Re: Updates and Revisions to the Site Plan for 2-6 Market Street

Re: Proposed Mixed-Use Development
2-6 Market Street
Newburyport, Massachusetts

Subject: 2-6 Market Street
Response to Engineering Review Comments

EXISTING CONDITIONS PLAN
SHEET: 1 OF 5

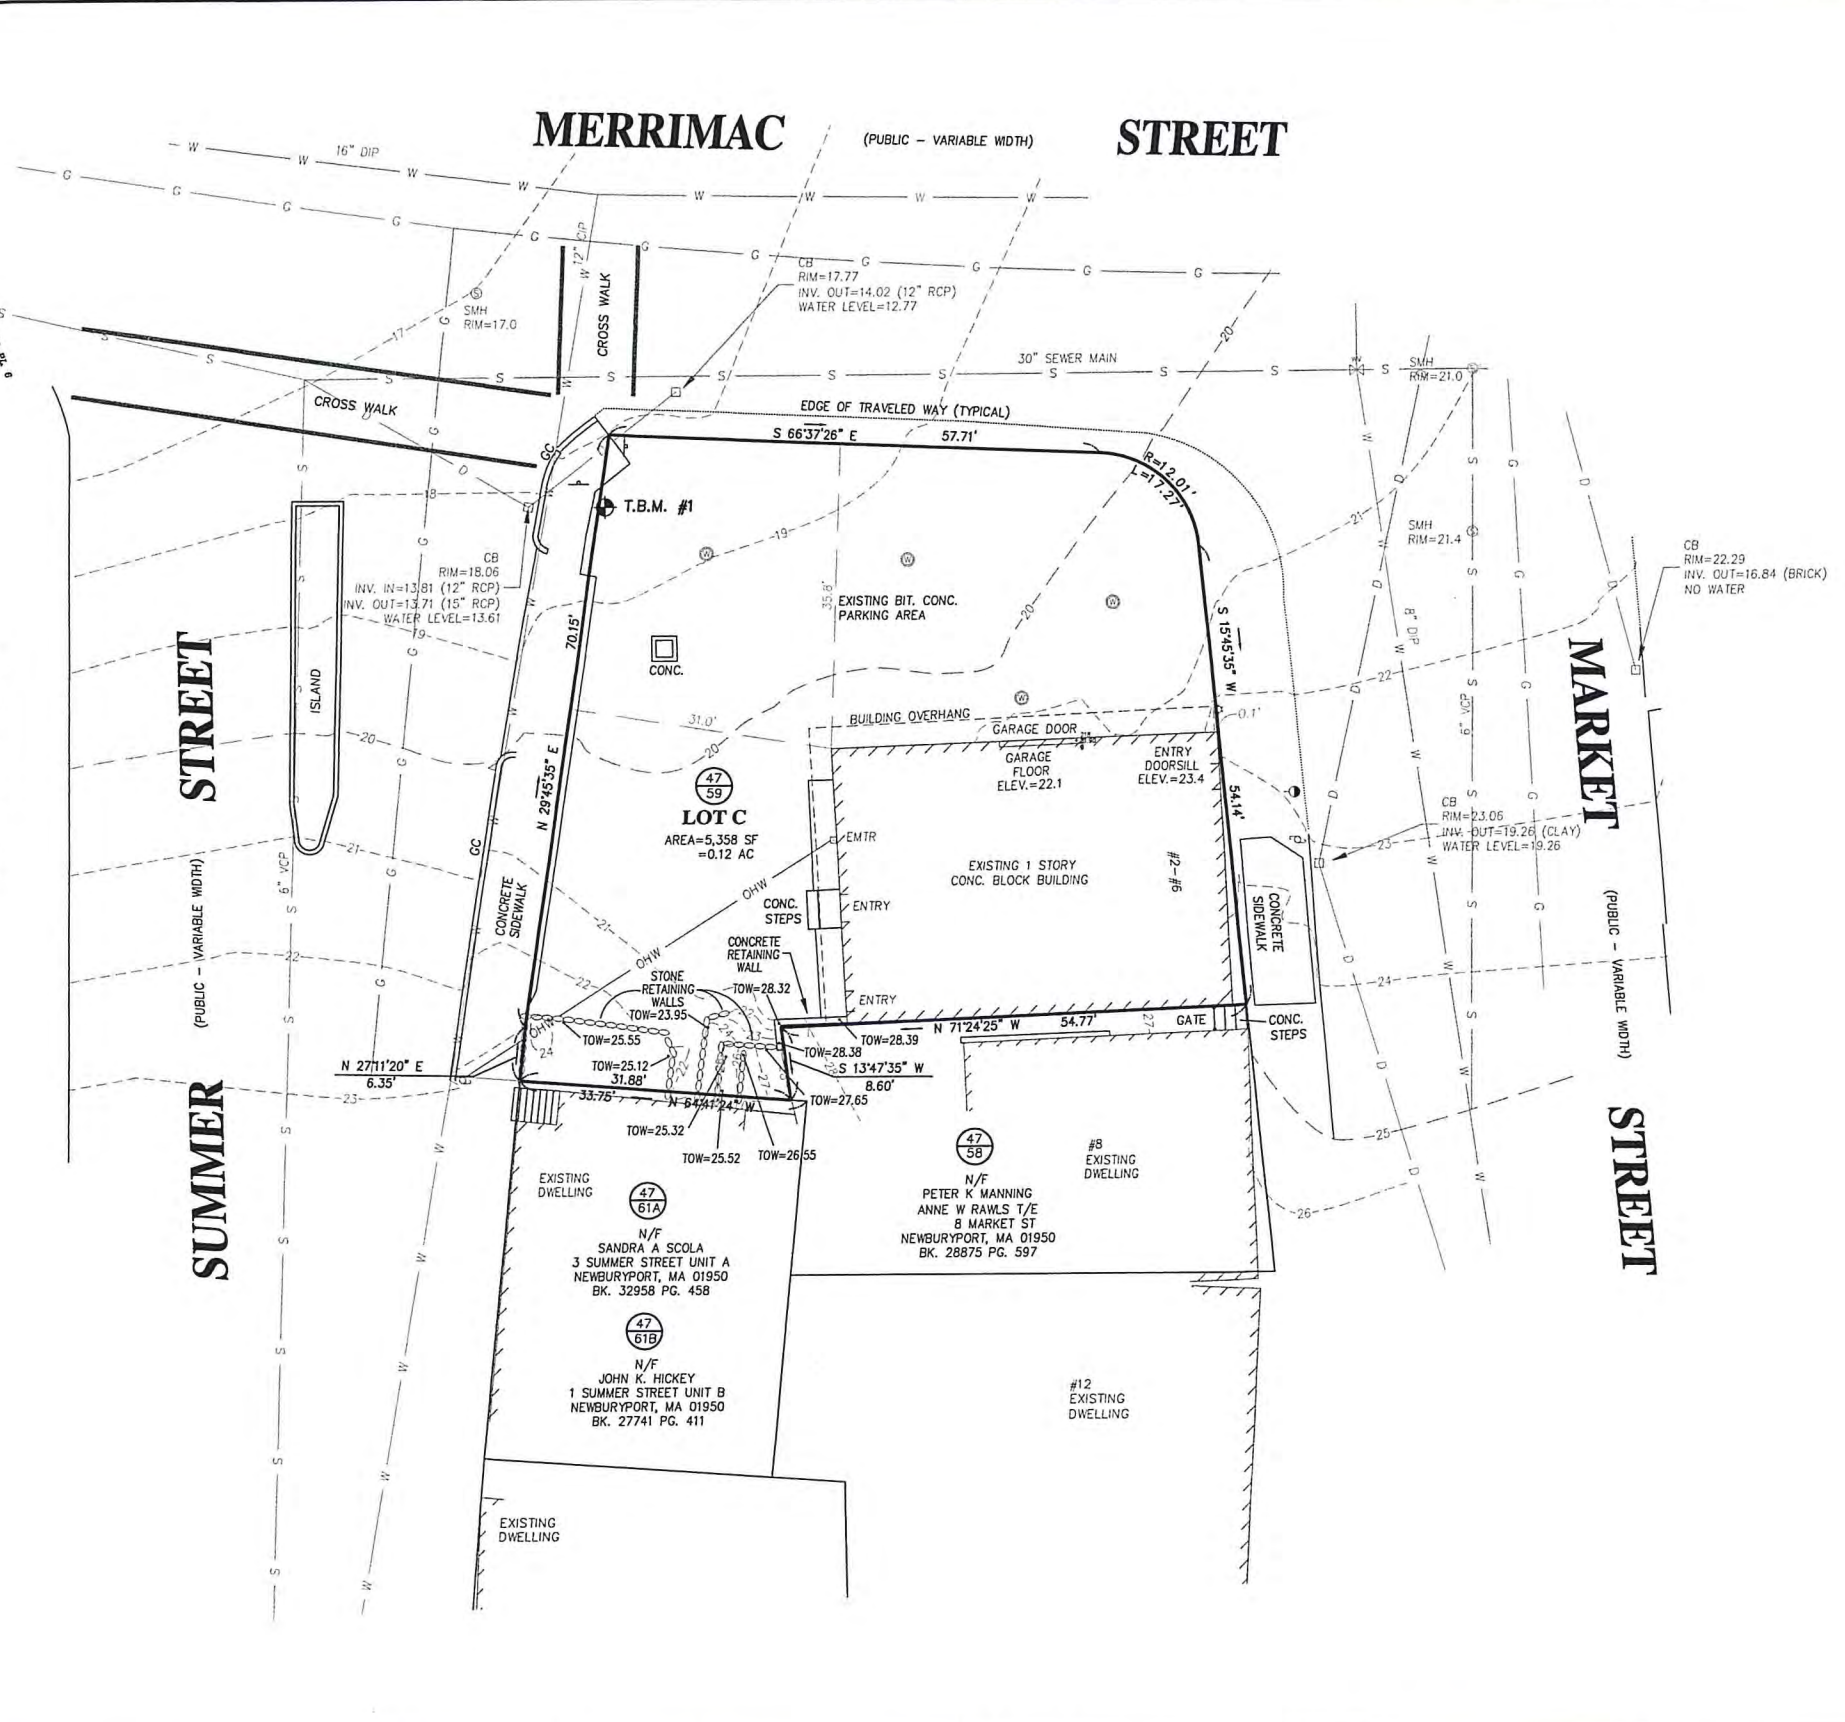
The existing conditions plan should be revised to show the location and size of water sewer and drain lines in Summer Street, Merrimac Street and Market Street as well as gas lines. Overhead lines should also be shown. Spot grades along the southerly property line should be provided. The location of existing water, sewer and gas services should be shown on the plan. The existing building on the lot is shown to be built against the property line as shown on the existing conditions plan.

Response: The various utilities within the roadways have been added to the plans. The location of the existing building services is unknown. However, it is our understanding that these utilities will have to be located and capped prior to building demolition. Spot grades have been added.

SITE PLAN
 SHEET: 2 OF 5

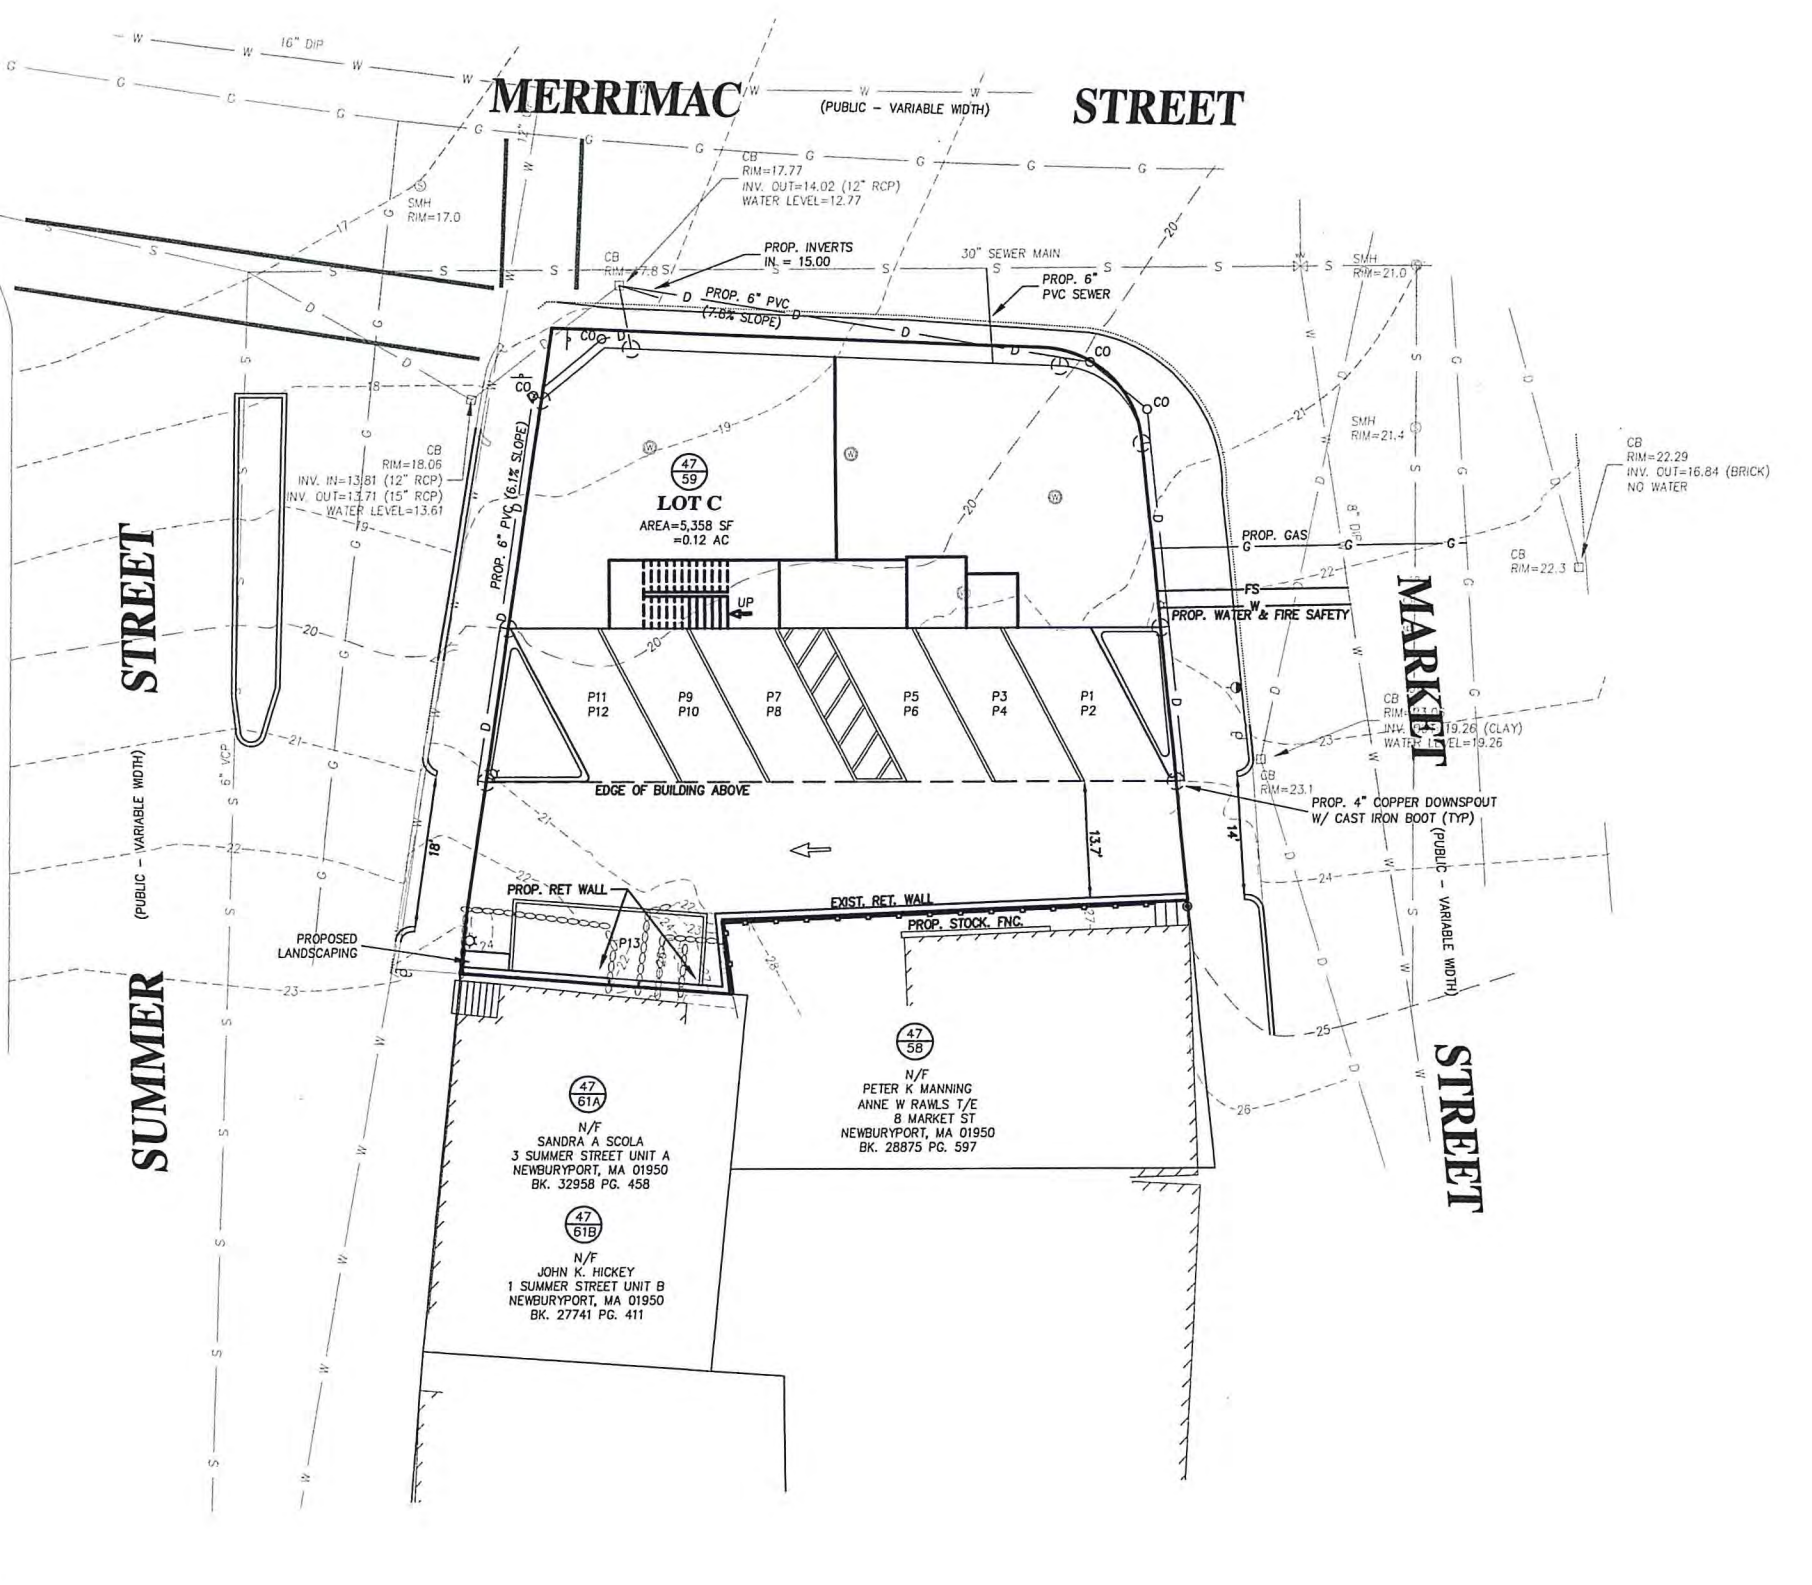
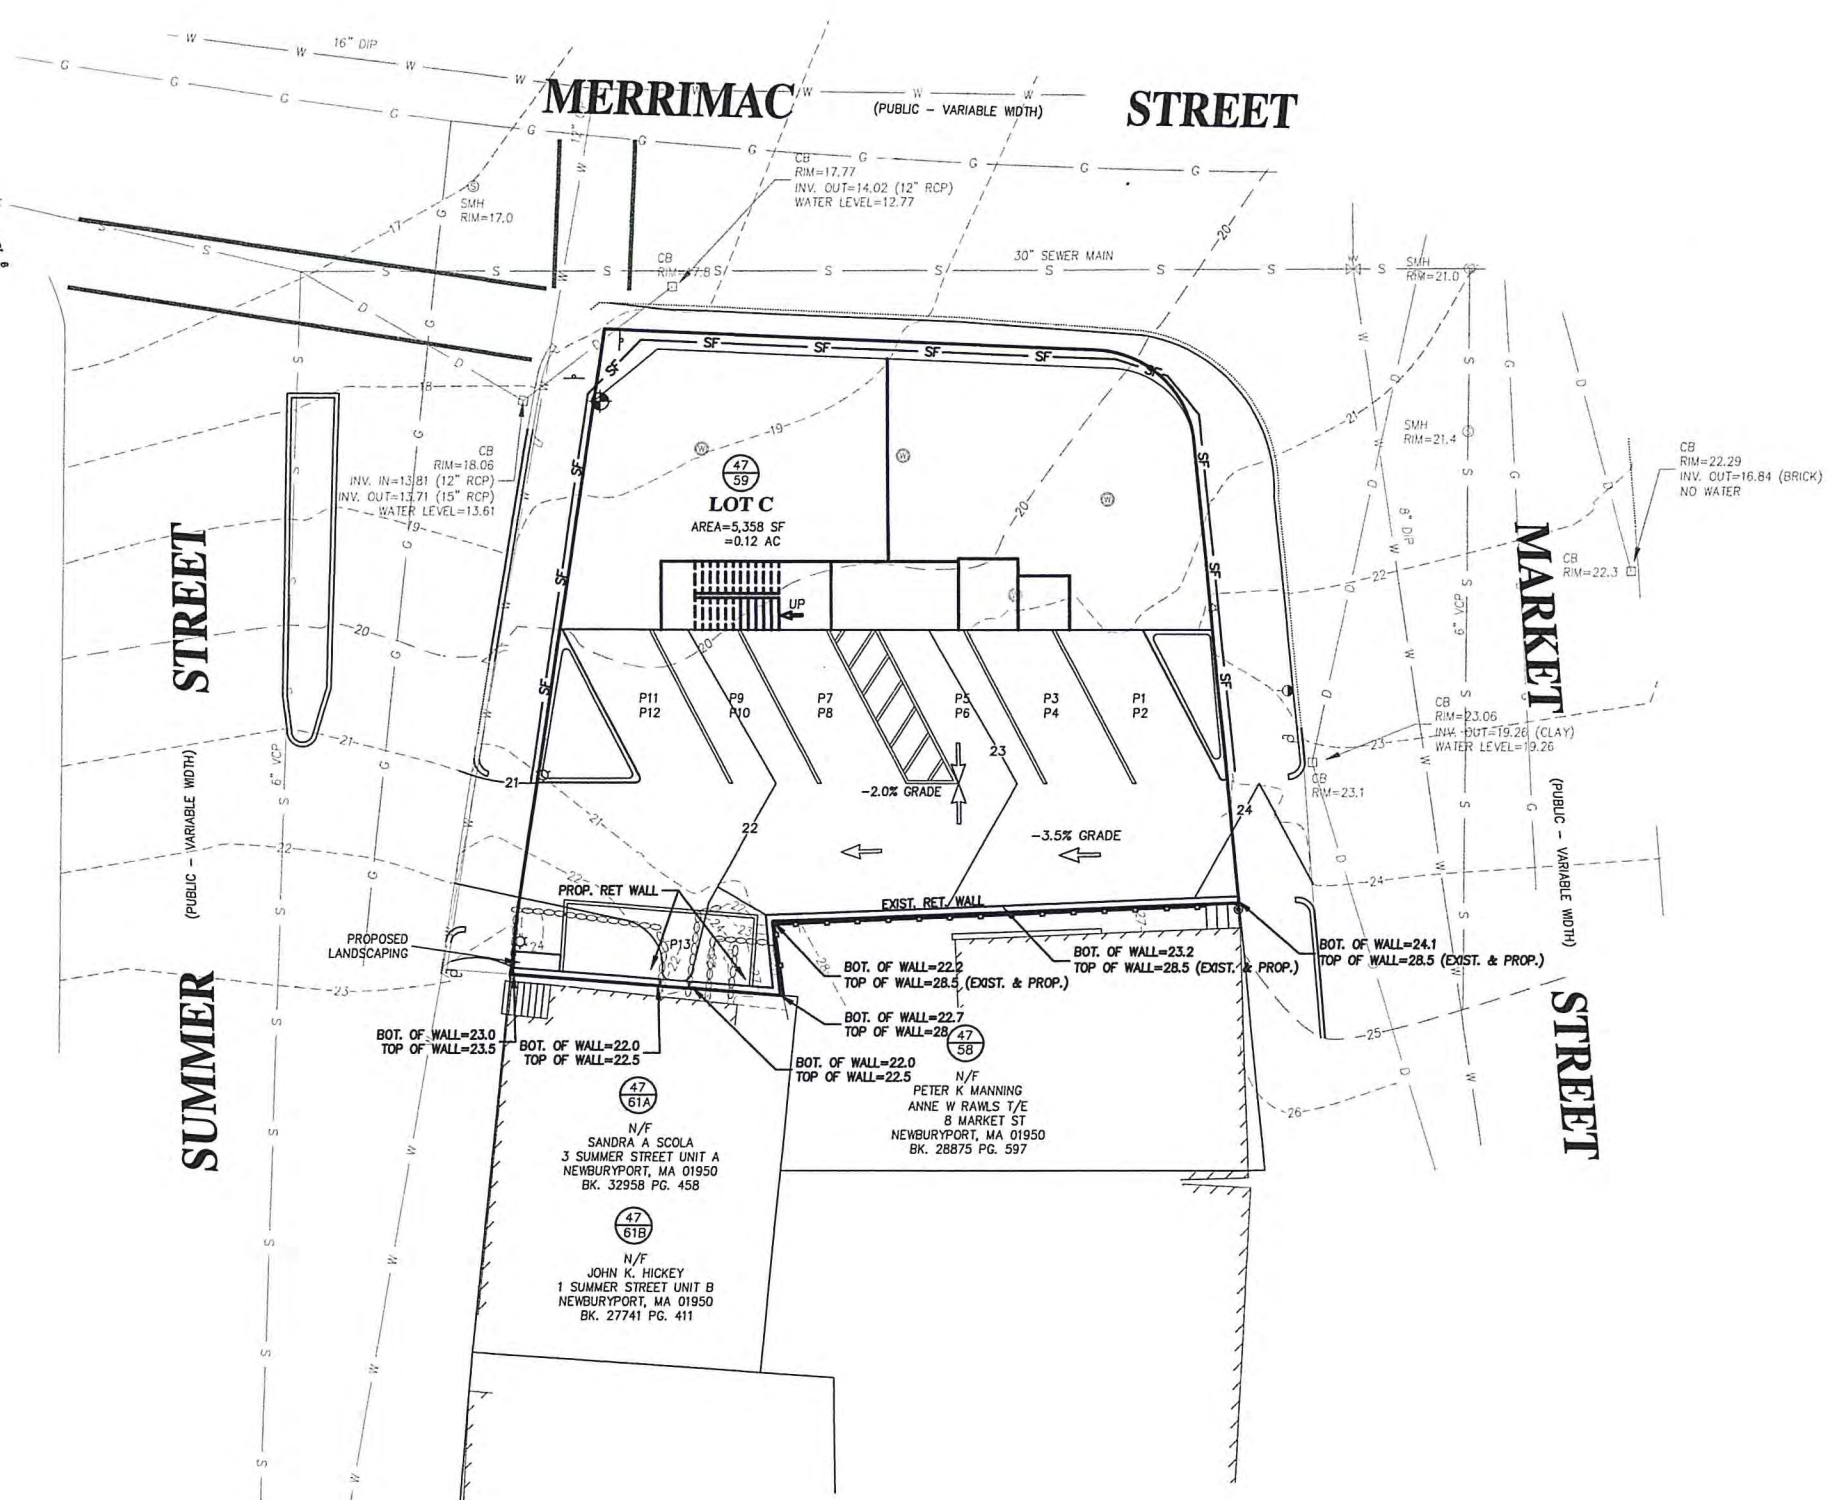
The plan should be revised to show the location of the proposed water, sewer and drain locations as well as gas and electric

The sewer service inverts at the proposed building and at the sewer line should be provided as well as the inverts on the sewer main into which the building will connect as well as the pipe size and slope and direction of flow.

Water service connections for domestic water and fire protection should be shown. The applicant should discuss with the Water Department if separate services are needed for the residential and commercial uses.

The location of the proposed retaining wall and elevations at bottom and top of wall should be added to the plan.

The location of downspout connections to the City's drainage system should be added to the plan. As well as the invert at the drain line and the invert at the building. The size and slope of the pipe into which the roof leaders will connect should also be provided.

The applicant should clarify if the building outline shown on the plan represents the walls of the proposed building or the overhangs of the building.

The curb line shown on the site plan at the intersection of Summer and Merrimac Streets does not match the curb line shown on the A1.0 drawing at that location.

The proposed fencing should be shown on the plan

Response: The plans have been updated accordingly (see sheet 2)

Response: The plans have been updated where possible. The connection details will be in accordance with the Newburyport Sewer Department recommendations.

Response: Proposed water connections have been added to the plans. We will coordinate the final design with the water department and adjust the plans if required.

Response: Elevations have been added accordingly

Response: The plans have been updated accordingly

Response: The building outlines shown are the building walls.

Response: The plans have been updated accordingly

Response: Proposed fencing has been added to the plans . Currently, this fencing is shown on the neighbor's property, as it is our intention to come to an agreement with the neighbor relative to this issue. If an agreement can't be reached, then the fence will be set on top of the retaining wall. At that point, the connection to the wall will be designed appropriately. The fence will be as shown or equivalent.
